Waukesha Water Utility

Re: Request for Approval of CP 5 - Change Order No. 003

Waukesha Water Utility
Great Lakes Water Supply Program
CP5 - Return Flow Pipeline
S.J. Louis Construction, Inc.
1351 Broadway Street W PO Box 459
Rockville MN
USA 56369

Submittal Item No.:	D-330522-002-011 Rev.: 0
Submittal Set No.:	330522-009 Rev.: 0
Description:	CROSSING PLAN 2 (DWG C123-C127) - SIGNED/SEALED CERTIFICATE OF PLAN AND CALCULATIONS
Expedited Review:	No
Review Disposition:	Acknowledged
Status:	Approved

SJL Construction
HDD#2-Unnamed
Tributary Pebble Brook

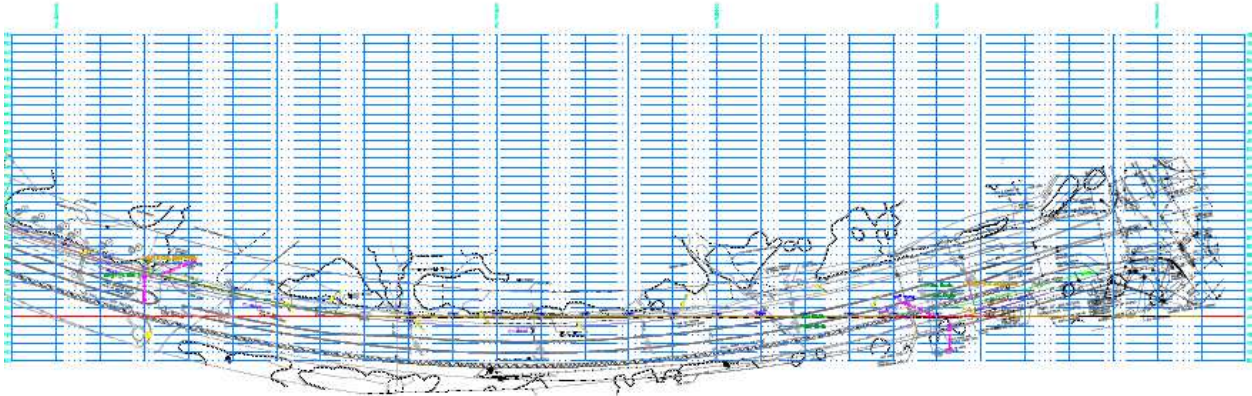
On August 6, 2021, Change Order Request No. 003 was submitted by S.J. Louis, regarding horizontal directional drill (HDD) work on Contract Package 5. This request was evaluated in detail by the Construction Management Team and discussed with me at length. I concur with the recommendation by Black & Veatch to approve the proposed revisions to the HDD on Les Paul Parkway adjacent to Sunset Drive.

The contractor is requesting an additional HDD length of 287 feet, which results in a net contract price increase of \$186,112.56. They are also requesting an associated contract time increase of 4 days. The request is being recommended for approval for the following primary reasons:

- Increased angles will allow depth to be achieved sooner and provide greater protection of the existing roadway and utilities.
- Insufficient room for pipe laydown on the original exit side of the HDD.
- Added length and depth to mitigate incidental return risks.

Recommended Motion: Move to approve of the noted portion of Change Order No. 003 for Contract Package 5 for a total of \$186,112.56 and 4 additional days of contract time.
